The Eggborough CCGT Project

Document Ref: 7.3 - Rev. 3.0

The Eggborough CCGT (Generating Station) Order

Statement of Common Ground with the Environment Agency

APPENDIX 1: CARBON CAPTURE PLANT INDICATIVE LAYOUT PLAN

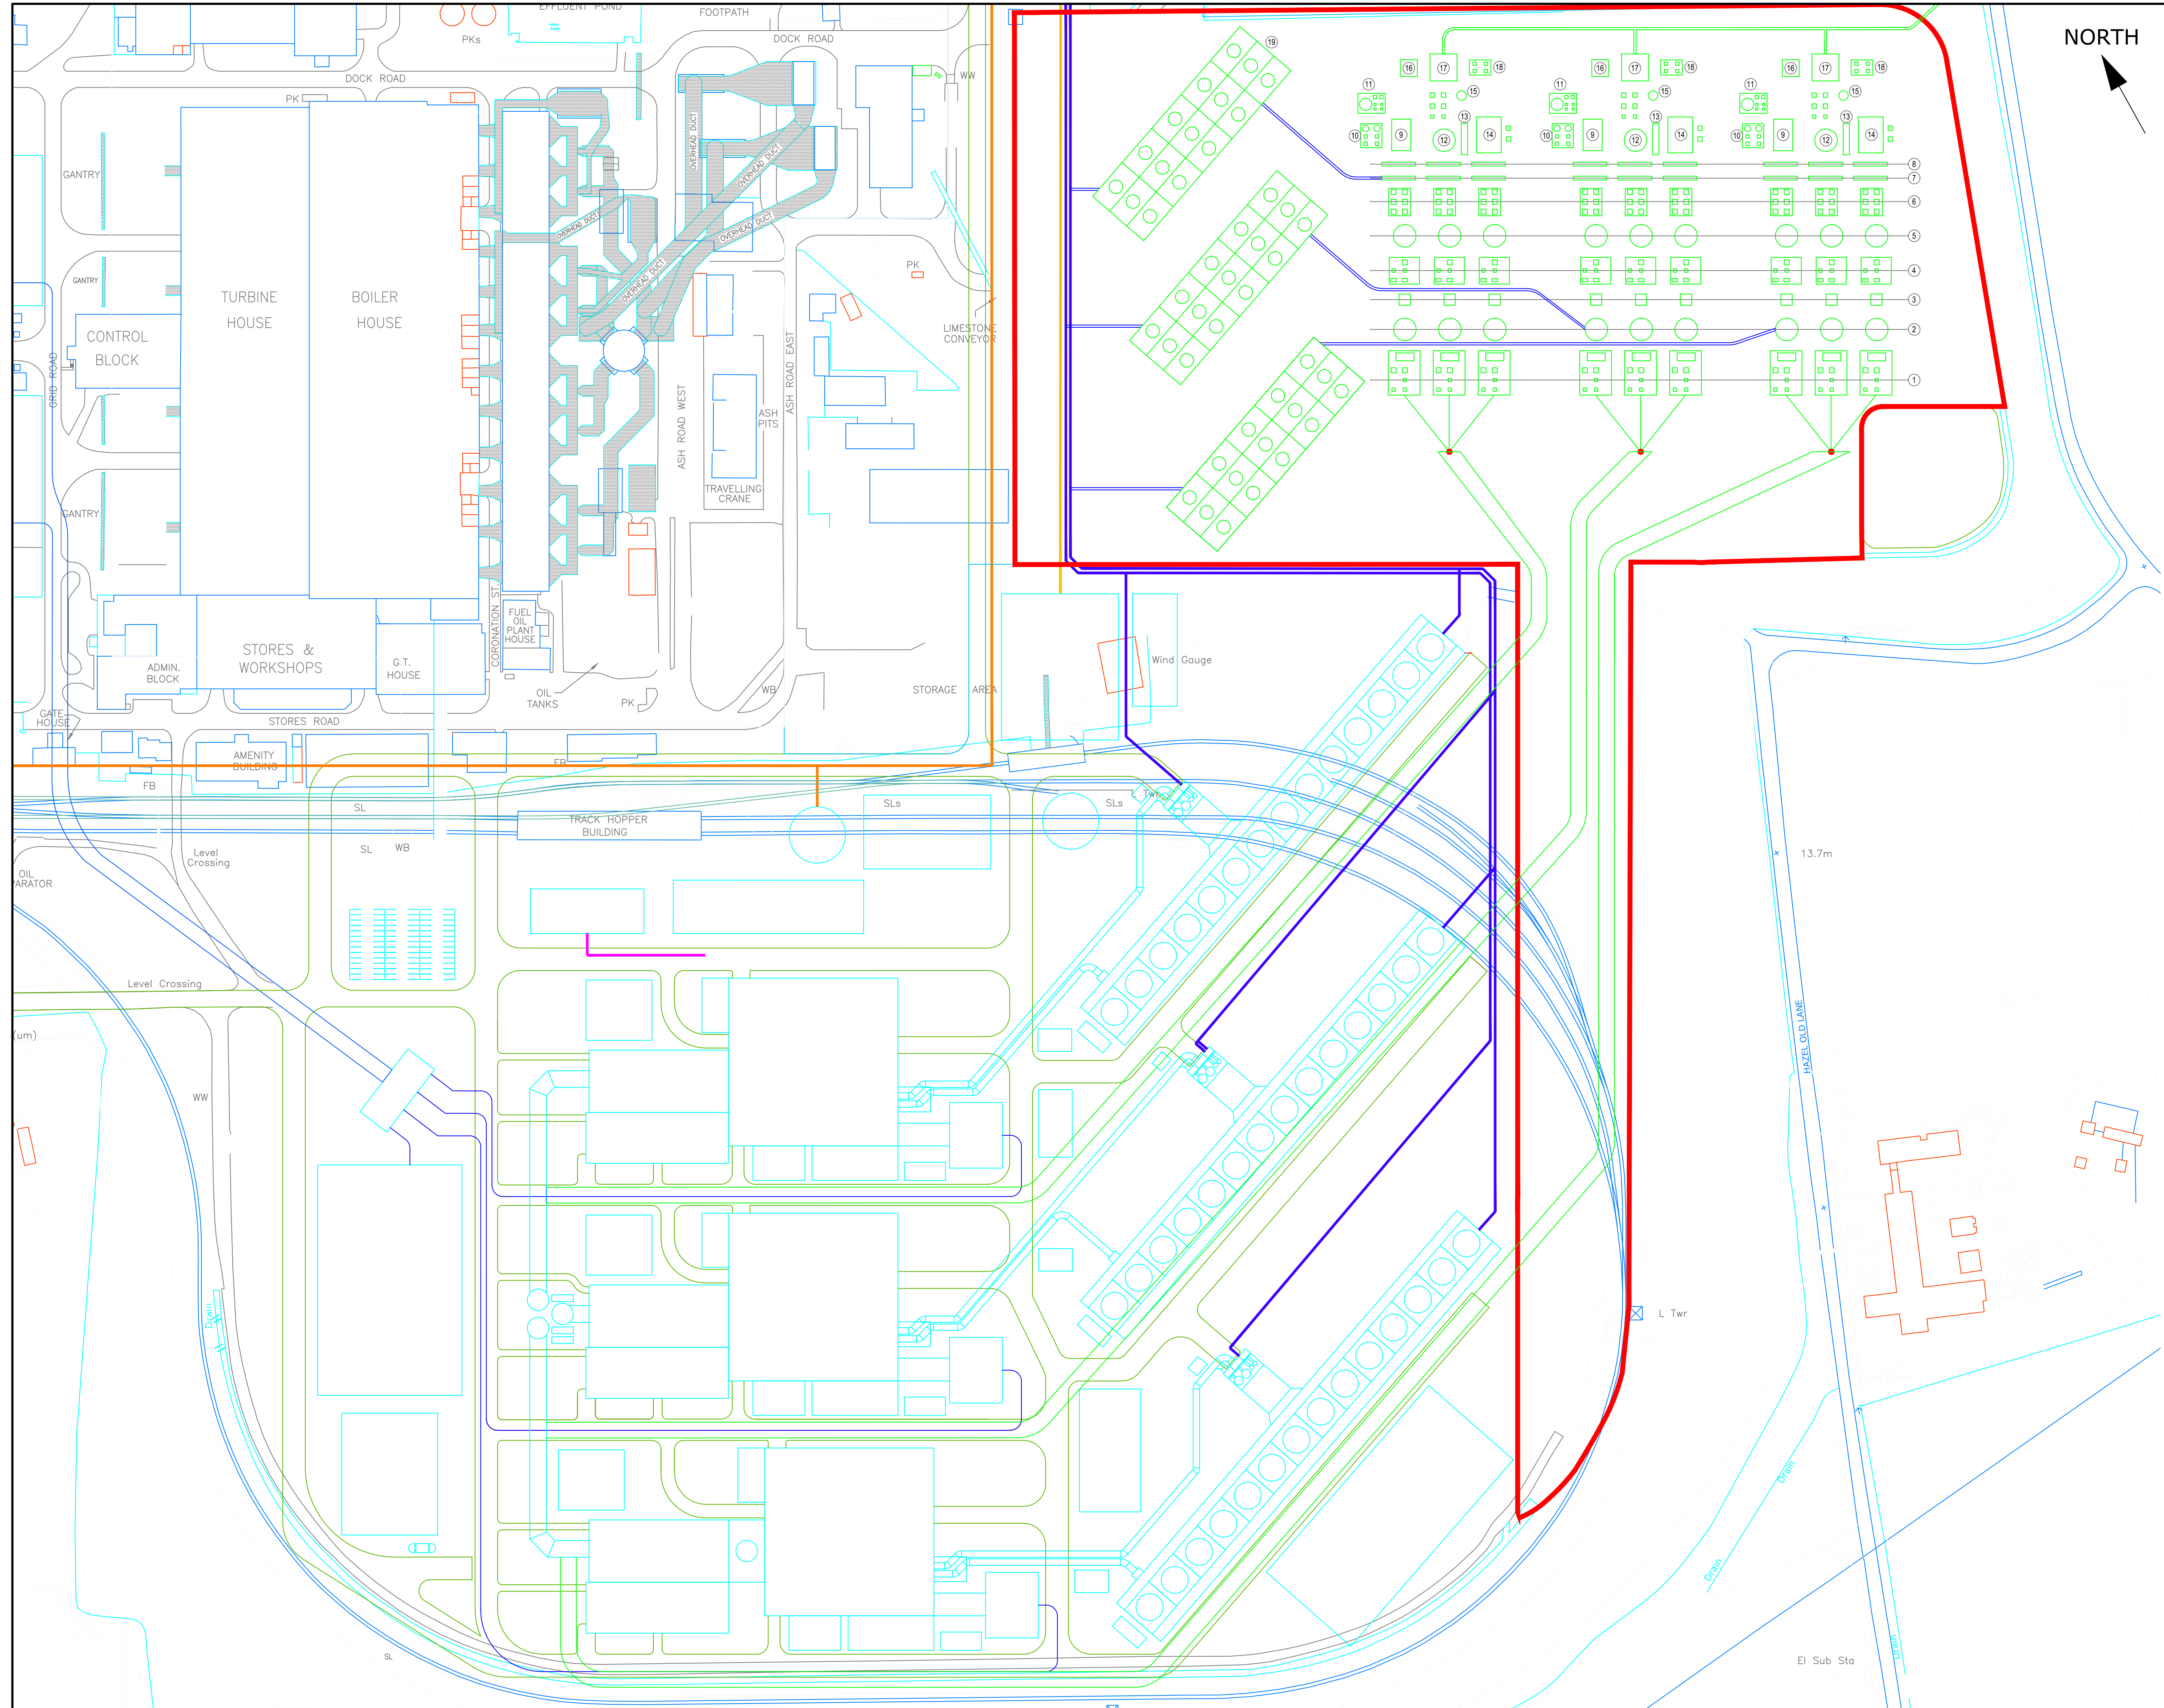
12.2 The EA initially disagreed with the statement in paragraph 11.1 that the CCR assessment demonstrates that the development meets the requirements of the CCR guidance (URN 09D/810). In its Relevant Representation the EA's Relevant Representation stated that before it could conclude that there are no foreseeable barriers to the technical feasibility of carbon capture retrofit, it required the following information:

“The location of the hybrid cooling towers dedicated to the carbon capture plant needs to be clearly identified on the plot plan (Figure 1); 2. The extent of the 120,000m² area allocated to the carbon capture plant and equipment needs to be clearly marked on the plot plan (Figure 1); 3. A statement is required on the sizing of the flue gas ductwork.”

12.3 An updated version of Figure 1 ‘Carbon Capture Indicative Layout - Rev. 2.0’ was provided to the EA in advance of Deadline 2. The EA has confirmed that the updated version of Figure 1 provides the necessary information. A copy of Figure 1 was submitted at Deadline 2 as Appendix 1 of Document Ref. 9.2 (The Applicant’s Comment on Relevant Representations).

12.4 On this basis, the EA accepts the conclusions of the CCR Assessment.
